Town of Parker Community Development Department
Development Review Division
Attention: **Jeremiah Fettig**

Application Type: **Site Plan – Non-Residential**
Status: **First Referral**
Application Name: Parker and Pine F1 L4 - Car Wash
Case/AP#: **SP20-118**
Referral Received: October 18, 2021
Comments Due: November 3, 2021

TOWN OF PARKER - FIRE/LIFE SAFETY: R REVIEWED FOR CODE COMPLIANCE; REVISIONS REQUIRED

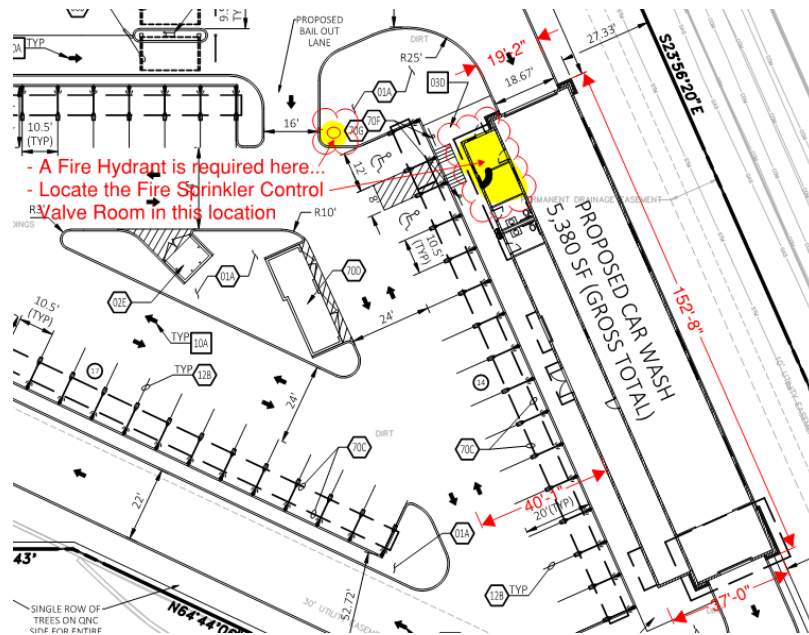
6. Based upon the size of the building (actual building 153'-0" x 37'-0"), it is not possible for the applicant to provide the required access to all portions of the building, as noted in [18 IFC 503.1.1 Buildings and Facilities]. This section states that “the fire apparatus access road shall comply with the requirements of this section and shall extend to within 150 feet of all portions of the facility and all portions of the exterior walls of the first story as measured by an approved route around the exterior of the building or facility”. Based upon the size of the building, $153' + 37' = 190$ feet (plus another 40 feet to center of the access that is perpendicular to the building), the access to all portions of the building would be approximately 230 feet... the requirement cannot be met. *Partially satisfied; applicant has not noted, acknowledged, or addressed with current submittal specific to this response though the plan set does appear to have addressed the fact that the building is required to be sprinklered. The applicant will address all requirements noted in this letter and response both in writing as well as in the documentation when submitting. Note – The riser room shall be located closer to the n/w corner of the building... in closer relationship to the required fire hydrant.*

The code does allow the fire code official to extend this access on the basis that the building is fully sprinklered per NFPA 13, as required by [18 IFC 903.1.1]. A sprinkler suppression system, installed in accordance with NFPA 13, is required for this building.

CEI RESPONSE:
To be addressed by others

CEI RESPONSE:
 Addressed. Fire Hydrant provided.
 . Fire Hydrant will tee at end of proposed main with blowoff valve.

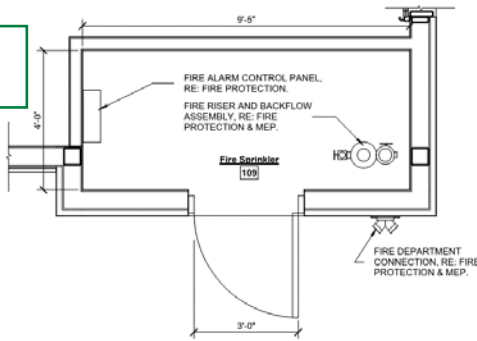
Note – The applicant shall be aware that the measurement starts center line of the access road perpendicular to the building and a at the center of the apparatus. Further, as hose does not bend at 90-degree angles, the measurement is much longer. Given that the measurement provided did not address the wing walls, stairs, etc., the hose pull extends even further. Given that the building is 153' long and 37 feet wide, the hose pull alone would be 190'. Add the 40 feet to the vehicle, and the hose pull for half of the building would be 230'. When adding in the radius of the hose (as it lays out) the configuration of the site would add an additional 50' to 75' to meet the hose pull requirement...
